TECHNICAL EVALUATION REPORT

OPERATING REACTOR PORV REPORTS (F-37)

WESTINGHOUSE OWNERS GROUP, WCAP-9804

February 15, 1983

Figure 4. Plant No. 7 (Baseline Case - Post TMI Data)

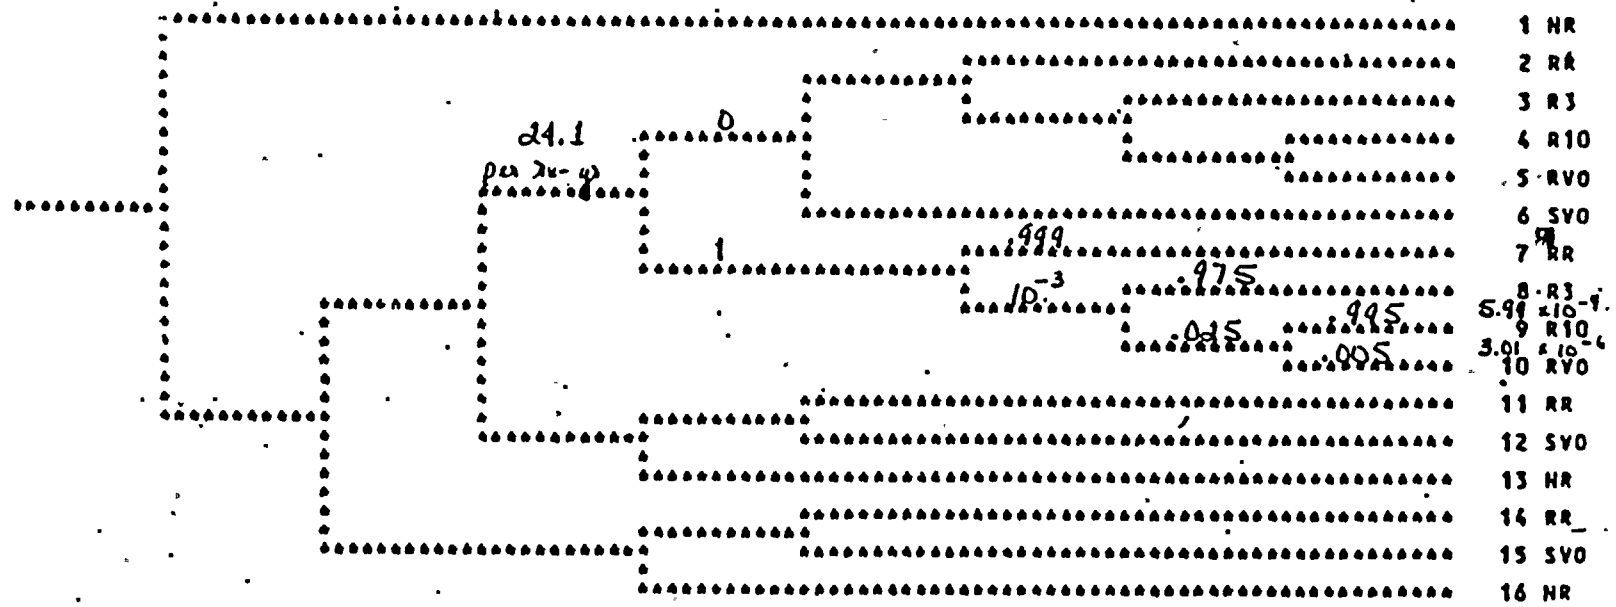
Calculation of the frequency of a small break LOCA from a stuck-open PORV is greatly reduced, in the case of plant No. 7, because only three types of initiator transients are involved (T-1, T-5, T-6), because the nodal parameters are the same for these three transients, and also because only a portion of the event tree is affected. As shown in Figure 4, the values of R_{10} and R_{VO} are calculated as follows:
